SERVICE BULLETIN

Classification:	Reference:	Date:
RA04-002d	NTB04-113d	October 6, 2011

2004-2012 ARMADA; CLICKING NOISE FROM REAR AXLES DURING TAKE-OFF/ACCELERATION

APPLIED VEHICLE: 2004-2012 Armada (TA60)

Figure 1 (Hub removal not necessary)

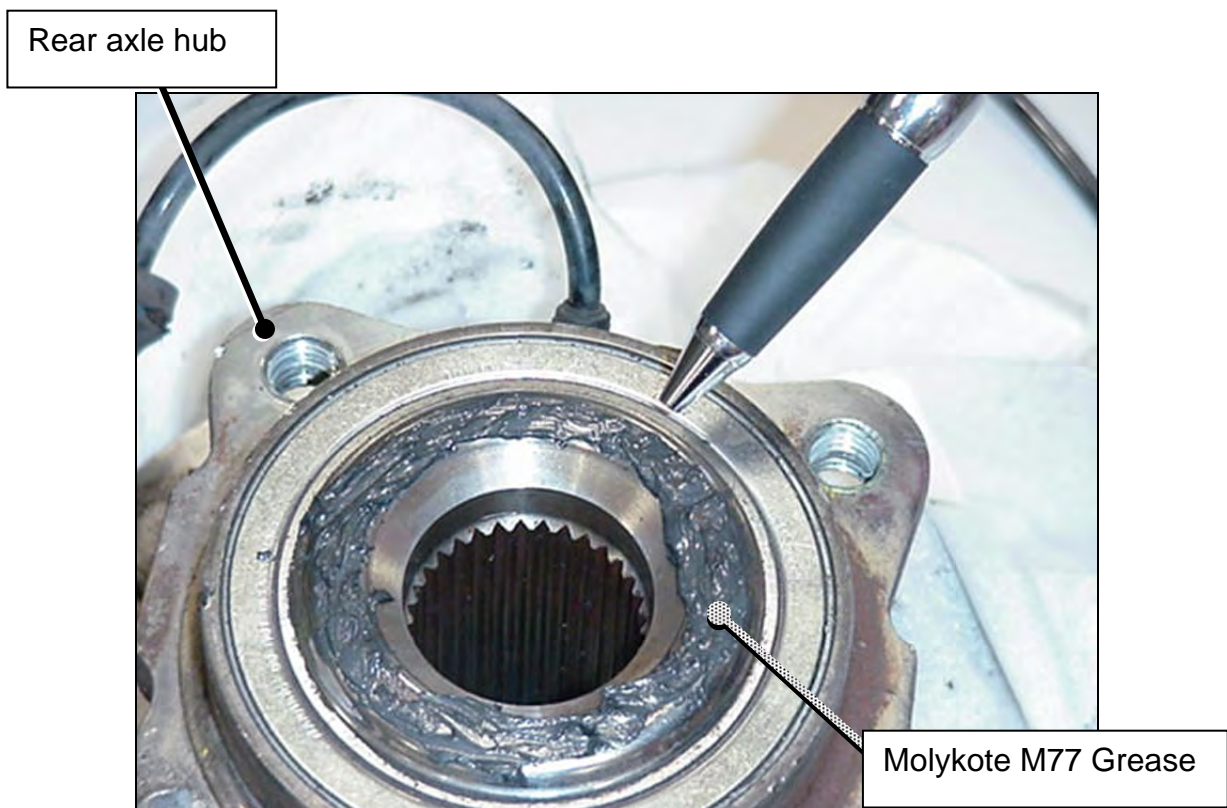
5. Slide the axle inward to expose the back side of the hub.
6. Clean all dirt and foreign material from both axle shaft-to-bearing mating surfaces.
7. Apply a minimum of 1.0g of Molykote M77 Grease (P/N 44003-7S000) in an even coating to the bearing surface where it contacts the rear axle (see Figure 1).

NOTE: Figure 1 shows the hub removed. This is done for easier viewing only. It is not necessary to remove the hub.

8. Slide the axle outward, and then re-secure the lock nuts to the following **new** torque specification:
 - 206 - 216 N•m (21 - 22 kg-m, **152 - 160 ft-lb**)
9. Install a new cotter pin (P/N 40073-0L700).
10. Perform steps 1-9 on the other axle.
11. Test drive the vehicle to confirm the incident is resolved.
